Name of Proposed Subdivision PANEX, LTD. ADDITION

Re: Panex Ltd Addition

We have reviewed the Plans for the above referenced project and offer the following comments regarding compliance with Rockwall's Standards of Design:

Re: Panex Ltd. Addition
ROK 83187

GRADING PLAN
CITY OF ROCKWALL
ROCKWALL COUNTY, TEXAS

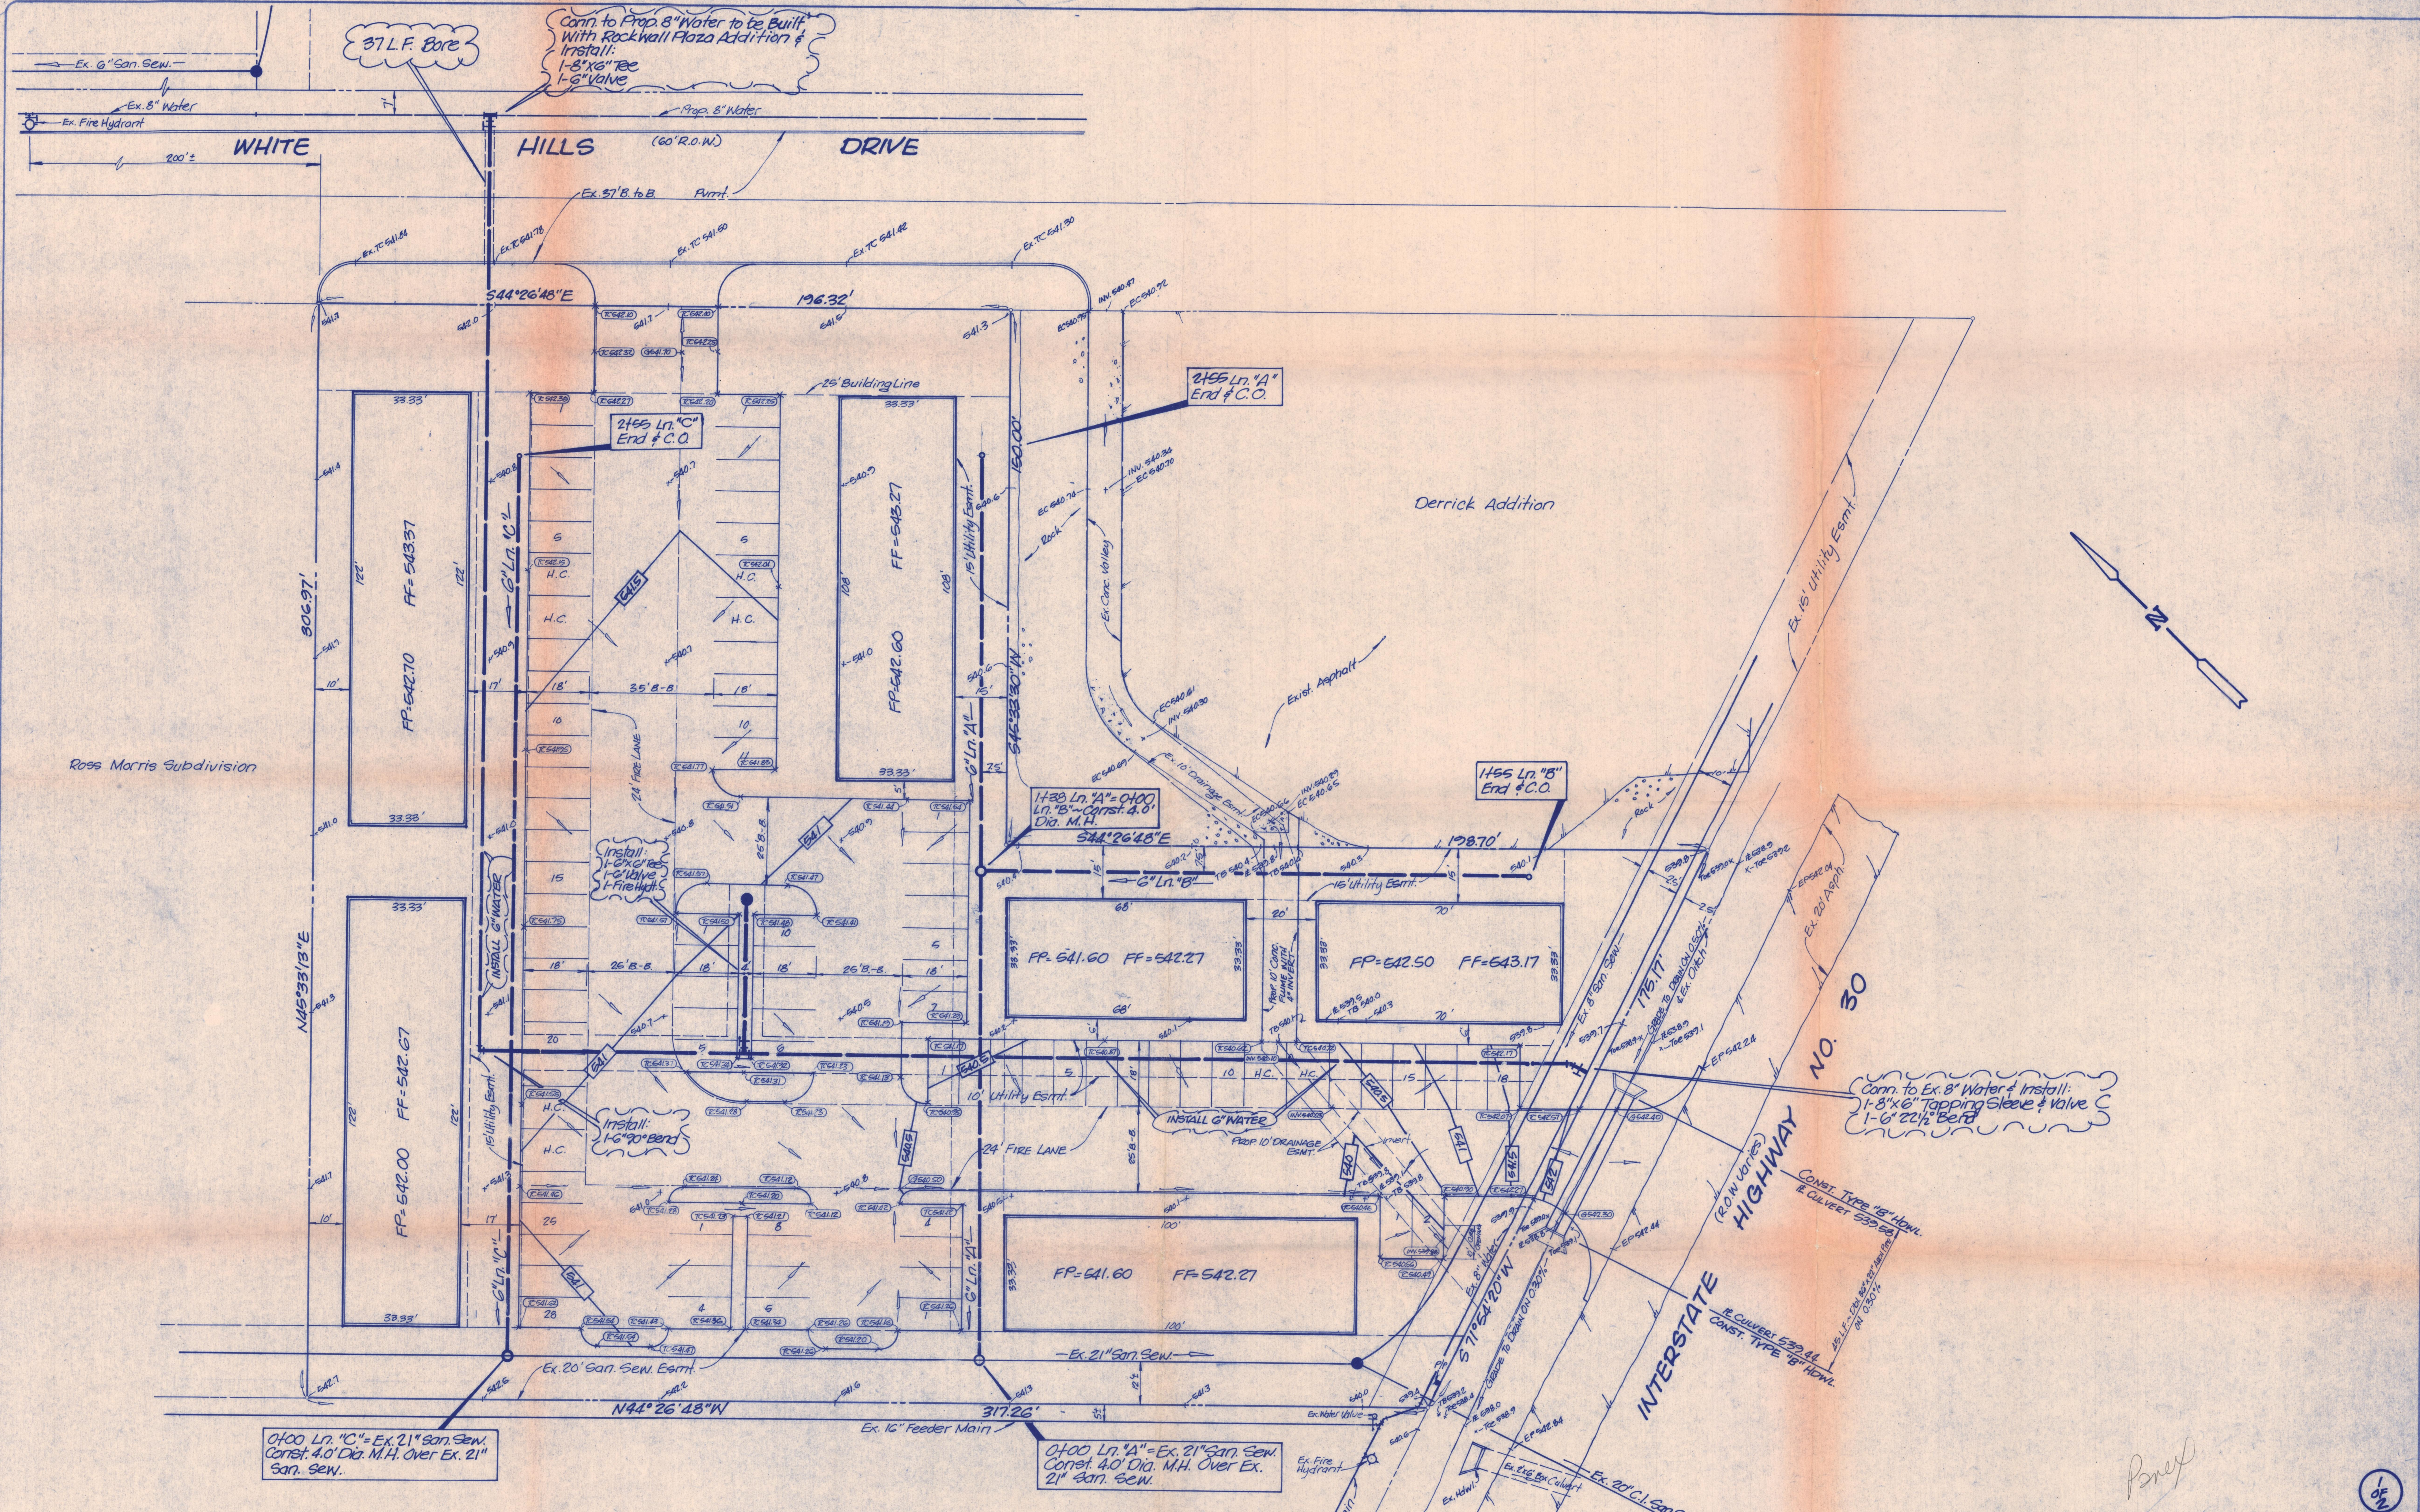
1. No calculations of flows were included, indicating the amount of upstream watershed contribution.
2. Is the flume capacity adequate for flows encountered in a 25-year storm?
3. Handicapped parking is shown to be within the drainage easement, over a four inch invert. It would be better to locate handicapped parking away from areas subject to flooding.

1. There seems to be an inconsistency in the rainfall data listed in the "Drainage Data" on sheet 3 of 5.
2. Based on the "Flume Design" information given on sheet 4 of 5, we find that the flume capacity will be exceeded above the flume curb elevation of 540.76 at section "A-A" during a 25-year flooding condition thereby exceeding the limits of the 10-foot drainage easement. We cannot verify the values for "V" and "C" shown on sheet 4 of 5.

3. It should also be noted that the flooding condition will be extended into the parking/driveway area. The water will probably not turn as desired when reaching the parking area from the flume section on the east.

4. Some of the flood water might be diverted behind the building at the southeast corner of the property into the drainage ditch along I.H. 30.
5. Headwalls details should be provided with attention given to common problem of erosion occurring adjacent to the headwall.
